# PREVOST

## WARRANTY BULLETIN

**WB17-02**

DATE :	April 2017	SECTION :	23 ACCESSORIES
EXPIRATION:	April 2019		
SUBJECT :	ADDITION OF AN EXTENSION TO THE LINEAR THERMAL DETECTOR (LTD)

3.1 The following images show a Linear Thermal Detector wire (LTD) installation where the EOL (End Of Line) resistor is found far from the intake air preheater. These images are used to illustrate a common installation. The actual installation on your vehicle may differ slightly.

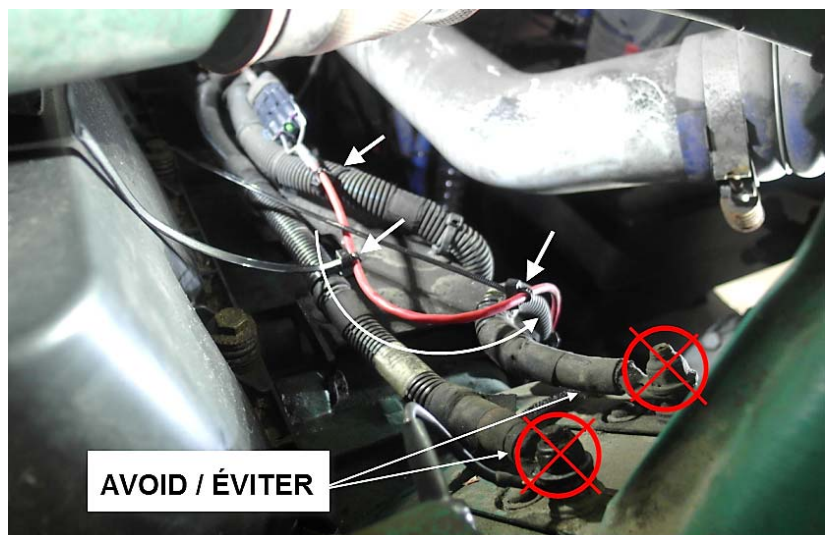
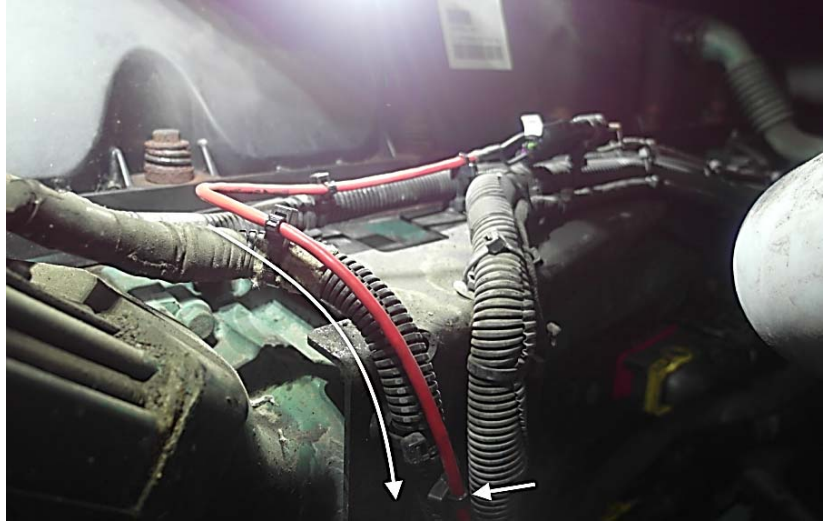
- 1) On the cold side of the engine, remove the End of Line (EOL) resistor from the existing LTD connector. **Keep the EOL resistor for reuse.**

- 2) Plug extension #069175 to the LTD connector. Make sure that the connector remains properly secured with a nylon tie.

**MAKE A CURVE WITH THE LTD AND THEN ROUTE IT DOWN ON THE PREHEATER GROUND CABLE (gnd-0B1-2). KEEP THE LTD CLEAR FROM THE PREHEATER STUDS.**

- 3) Route the LTD wire to a point forward of the upper alternator. The terminus point will vary from one vehicle to another.

- 4) Under the intake air preheater.

- 5) Plug the EOL resistor at the end of the extension.

*NOTE: secure the extension with double loop cable ties at least every 4 inches. Follow the various guidelines highlighted in PART 1 of this bulletin.*

*NOTE: respect the 2 inches radii.*

**3.2 The following images show a LTD installation where the EOL (End Of Line) resistor is found close to the intake air preheater. The actual installation on your vehicle may differ slightly.**

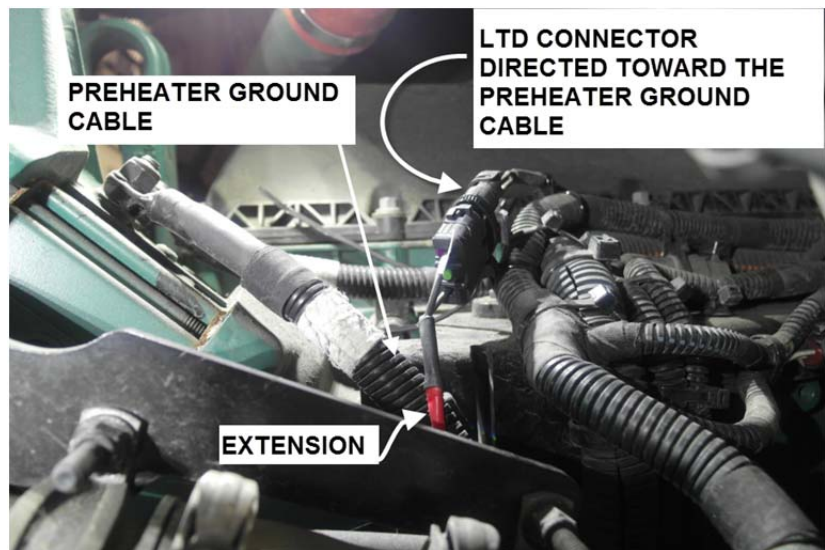
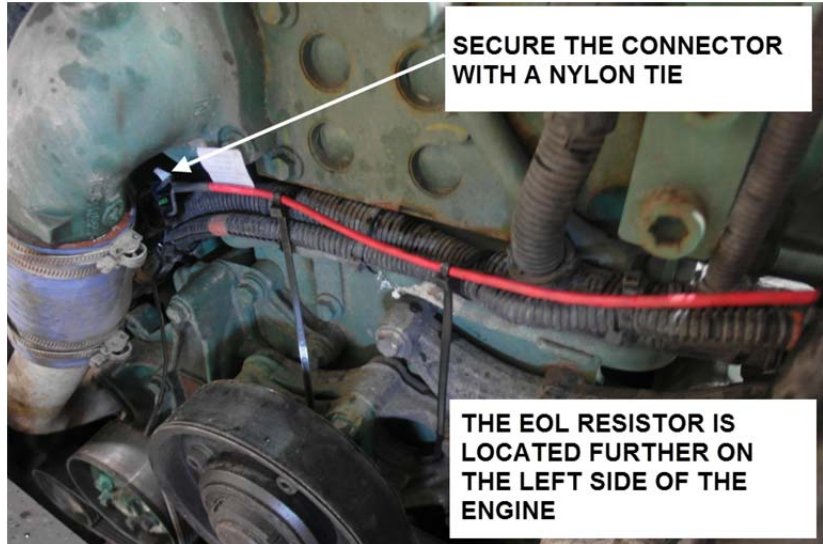
- 1) The LTD connector is located near the intake air preheater; it is therefore directed toward the descending section of the ground cable. Keep the extension clear from the preheater studs.

- 2) Consequently, the EOL resistor is located farther on the left side of the engine.

*NOTE: the connector must be securely attached using a nylon tie.*

*NOTE: The connector must be securely attached using a nylon tie.*
